N9935A-01

S E R V I C E N O T E

N9935A - FieldFox Handheld Analyzer

FieldFox instruments with the serial numbers listed on the following page are being returned to Agilent factory so the RF board can be upgraded for reliability enhancement, due to possible oscillation by the voltage regulator on the RF board.

Figure 1: No sidebands issue

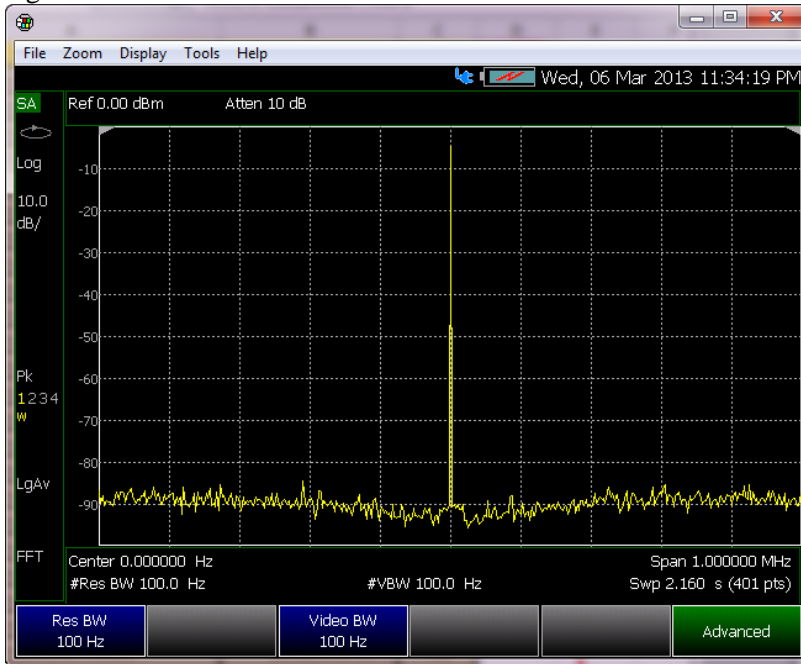
Figure 1 shows a good RF signal, and Figure 2 shows FieldFox with sidebands issue.

Figure 2: Sidebands issue between 112 - 116 kHz

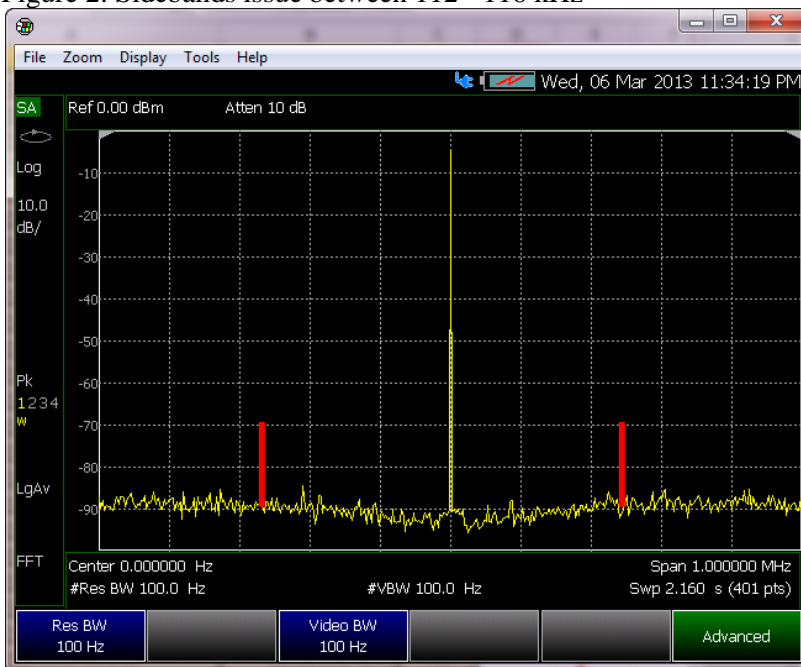
RF board earlier than Rev 7 may have sidebands issue due to oscillation by the voltage regulator. After it is fixed by replacing a new inductor, the RF board revision header will be updated to reflect the change.

Affected FieldFox are required to send back to Agilent factory for RF board reliability enhancement. The RF board revision header will be updated to reflect the change. Test and Adjustment shall be done before shipping back to customer.
